From: Simon Bareham <simon.bareham@lewisplanning.co.uk>
Sent: 21 July 2025 12:01:28 UTC+01:00
To: "Anna Tidey" <anna.tidey@midsussex.gov.uk>
Subject: RE: Barn 2 - Amended Plans for Application DM/25/1025 - Providence Farm, Colwood Lane, Warninglid

Subject: FW: Request for Amended Plans/Follow up to site visit for Applications DM/25/1024 and DM/25/1025 - Providence Farm, Colwood Lane, Warninglid

As submitted for DM/25/1024 – for Barn 1 - Proposed Elevations and Location Plan – Drawing ref FRFC_Wrngld_02_BR_02_E :

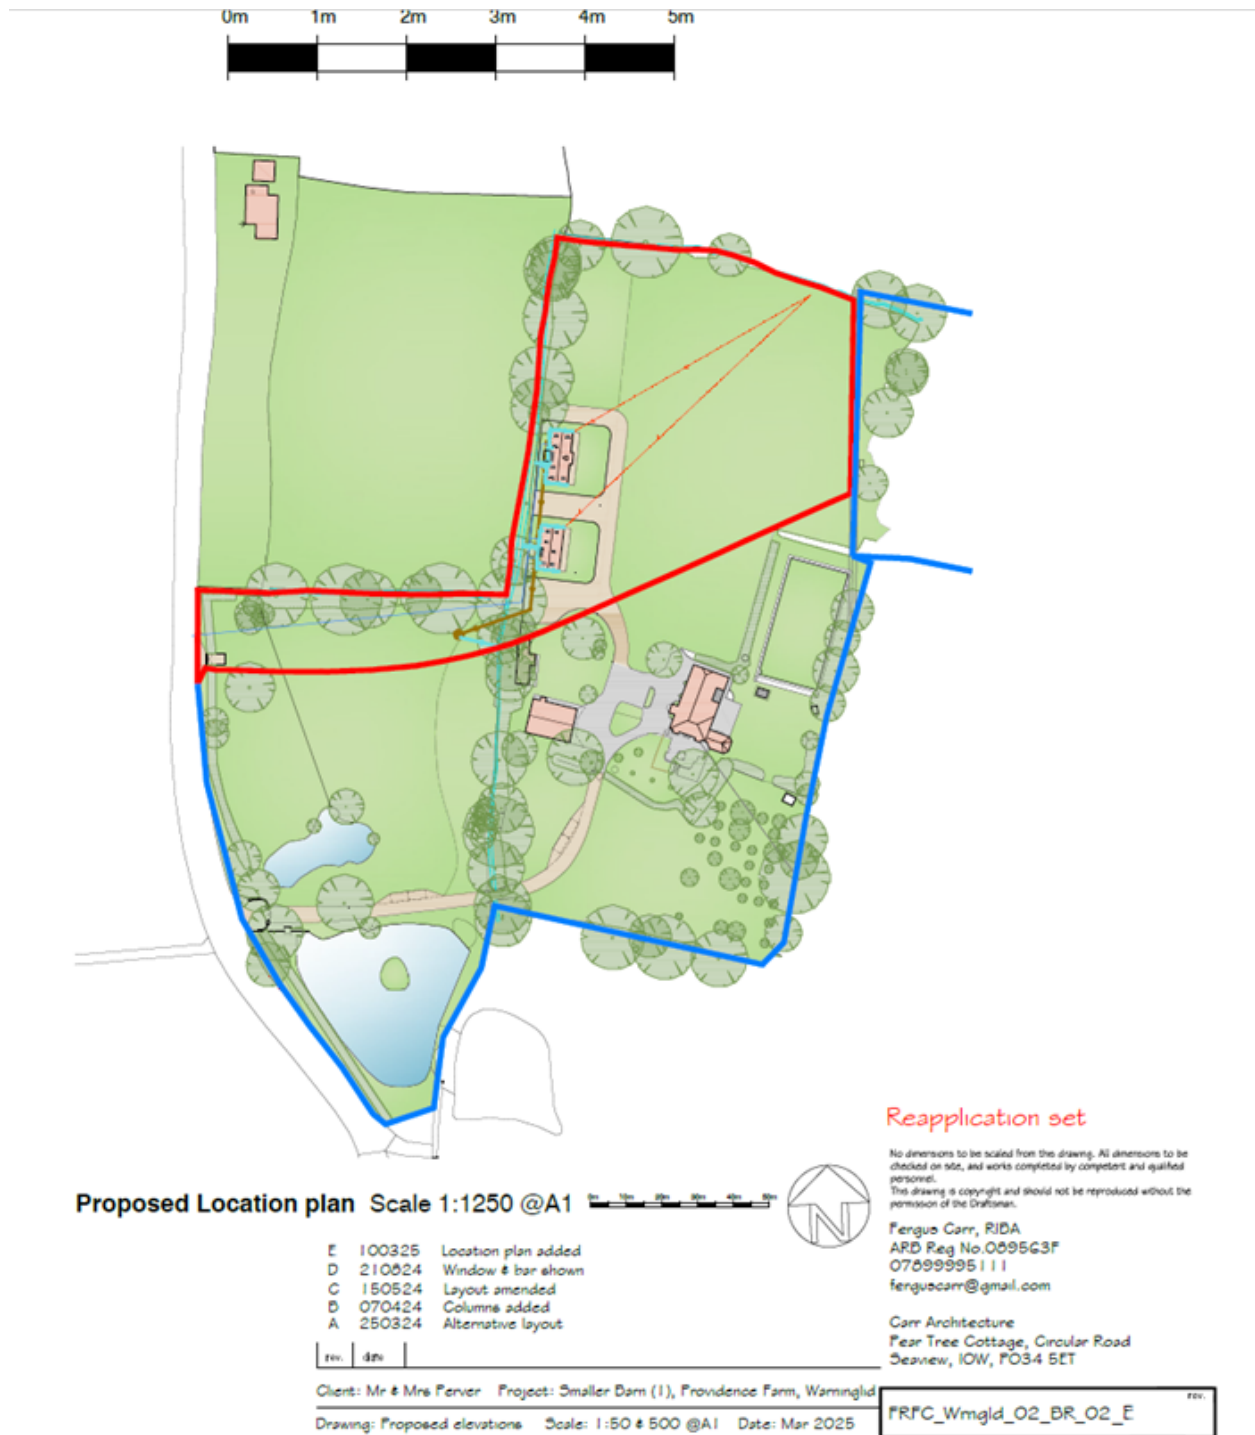
In order to take the applications forward to a positive recommendation I shall be grateful if you can please provide a revised Proposed Elevations and Location Plan with the red line to accord with the approved plan.

FRFC_Wrngld_04_BR_EX_02

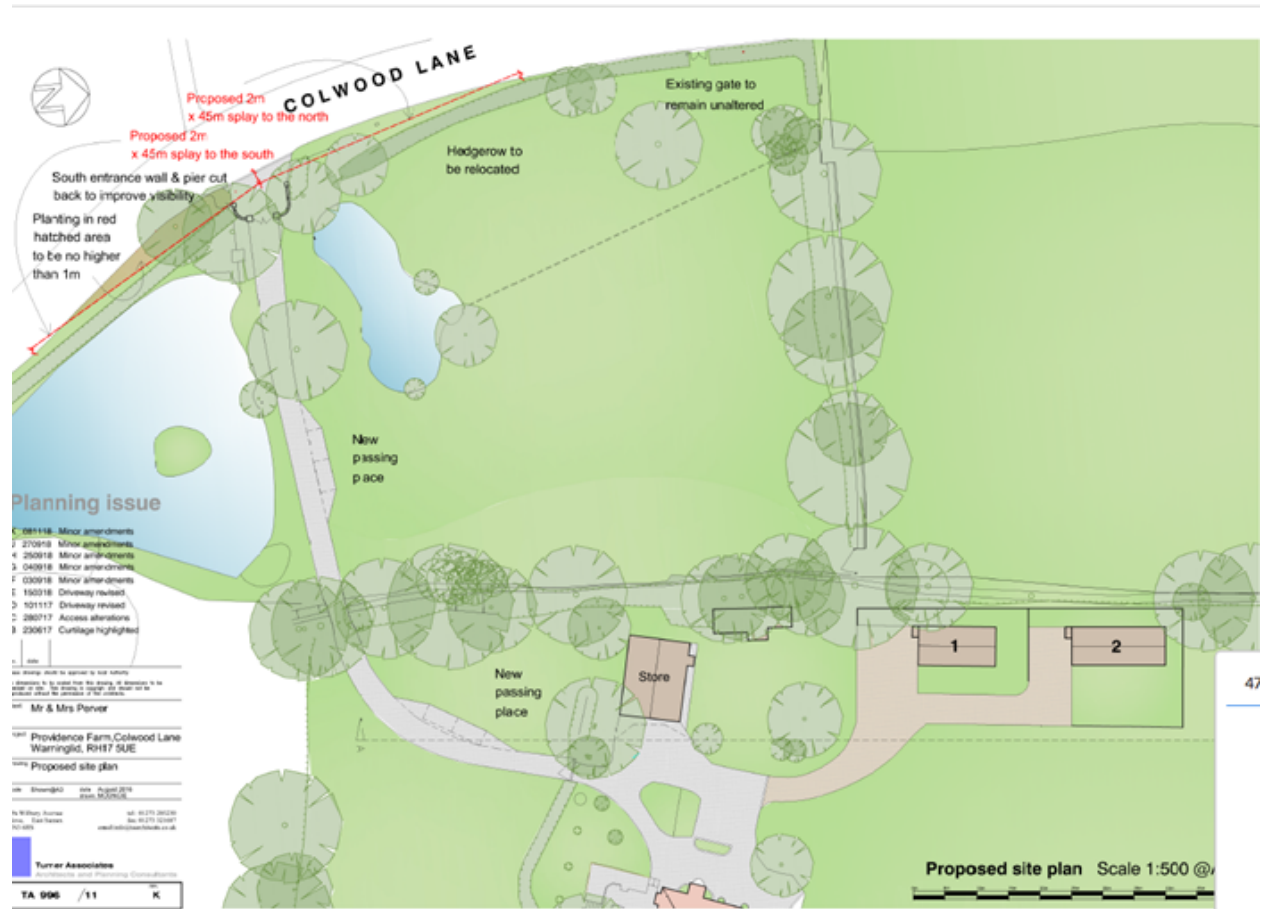
As submitted for DM/25/1025 – for Barn 2 - Existing/as built elevations, Sections and Plan – Drawing ref FRFC_Wrngld_04_BR_EX_02:

In order to take the applications forward to a positive recommendation I shall be grateful if you can please provide a revised Proposed Elevations and Location Plan with the red line to accord with the approved plan, see below.

A change to the front door at Barn 2 has also taken place, with a glazed door in place of an approved solid central door in the eastern facing elevation. **May I suggest that the Proposed Plans for DM/25/1024 (Drawing ref FRFC_Wrngld_04_BR_EX_02) is also amended to correctly reflect the works that have been carried out on site.**
